# Memorandum

Recipient Name: Dave Connor / Randal Beal  
Recipient Organisation: Environment Southland  
Issue Date: 2 October 2024  
Author: Matthew Gardner

## SUBJECT: RESPONSE TO MINUTE OF HEARING INTRODUCTION

Figure 2 – Historic Tide Level data

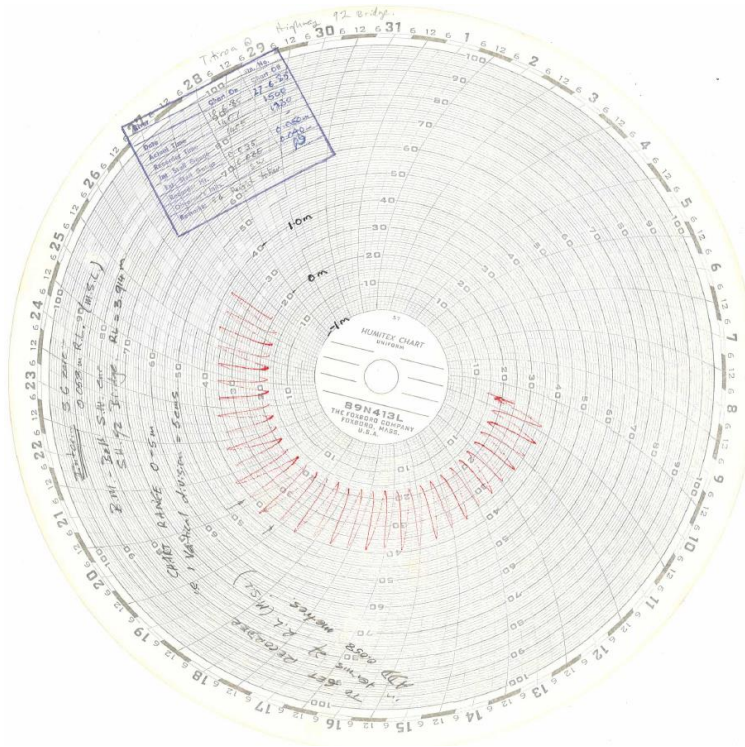
We have been provided with a scanned copy of one year's worth of data and have digitised these and converted them to the same vertical datum as used in the model (NZVD2016). An example of the original scanned data is shown in Figure 2 below. A digitisation of a single months data is shown in Figure 3 and a plot of the modelled neap tide and mean tide scenarios at the same location is shown in Figure 4 confirming that our model accurately replicates similar tide ranges to that recorded in the 1980's at the bridge location.

Figure 3 – An example of a typical months tide data

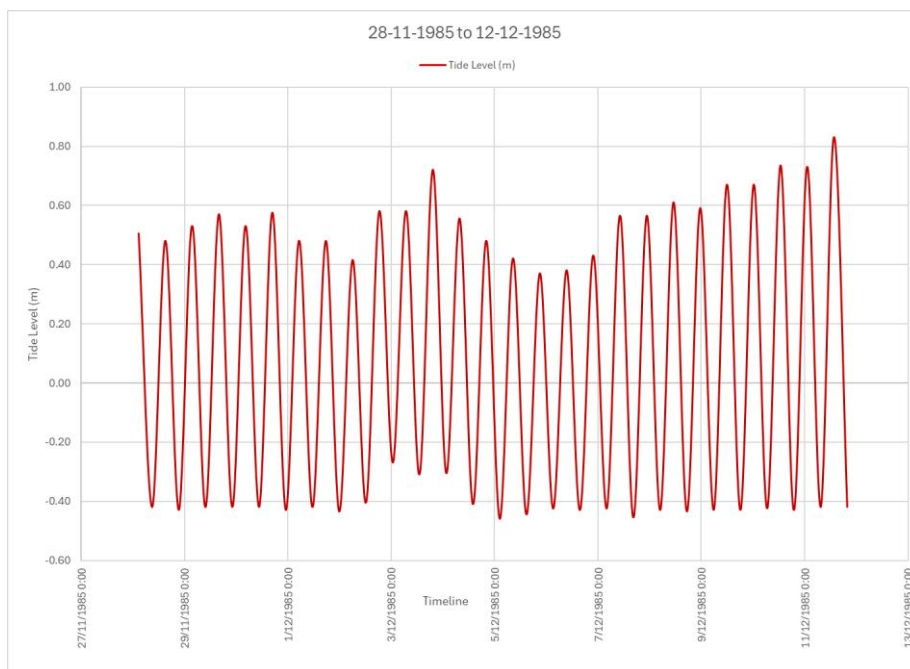
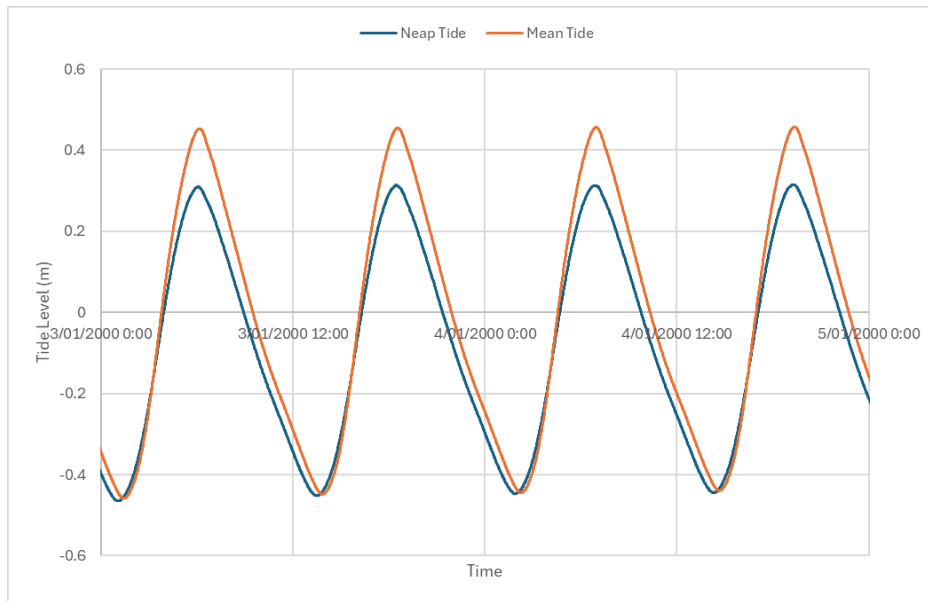
The historical data also show that the tide range at the bridge site varies significantly from day to day and is clearly heavily influenced by sea conditions. The peak water level for a high tide cycle range in the historic data ranged from around 0.4m to 1.2 m. It is also important to note that Les Frisby indicates the gates overtop during a king tide which indicates that water levels are even higher than this in recent times (with the top of the gate having a level of 1.35 m).

Figure 5 – Location of surveyed tile drains

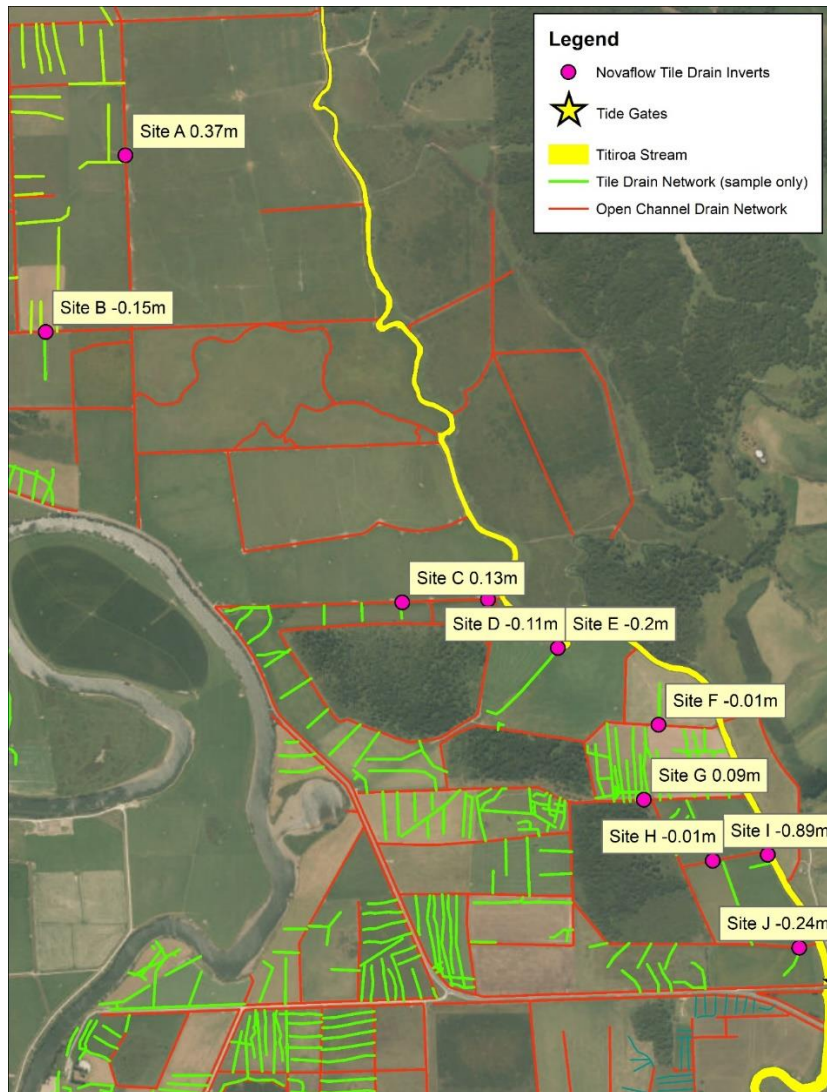
- a) At section 3.4, the Model Build Report stated that various tide scenarios had not been modelled and that the model was simply demonstrating the trends within the system. It would assist myself and the submitters if the model can be run to determine at what water level it becomes apparent that the tide waters will have a more than minor effect on the upstream improved pasture land.
- b) Clarification on what area of land would be affected by the removal of the gates. (Several figures, ranging from 9 hectares to 11,500 hectares have been referenced within the various documents).
- c) Assessment of how the gates may be modified to enable the passage of kanakana.
- d) Assessment of the downstream effects of removing the gate. What impact would this have on habitat now adapted to the current situation?

As requested by the Commissioner the model has been run again and it shows that at all tide scenarios, including during neap and mean tides, water levels within the drainage network will

exceed the level of the tile drains during high tide periods, if the tide gates were to be removed. The methodology used to reach that conclusion is set out below.

We have run the model again with both a neap tide and a mean tide scenario, based on the Land Information New Zealand (LINZ) tide tables for Bluff and find that even with these tide scenarios which have a lower range and peak water level, the majority of the surveyed tile drains will be completed inundated if the gate was to be removed, however the drains manage to flow freely if the tide gate is in place. A summary of the modelled peak water levels is presented in Table 1 and Table 2 below with the location of the surveyed tile drain outlets shown in Figure 5.

These results show that the tide gates are critical for allowing on farm drainage, even during neap and mean tide scenarios which will occur on a daily basis. Removing the gates is likely to limit drainage within the tile drain network, even during low tide ranges and water levels.
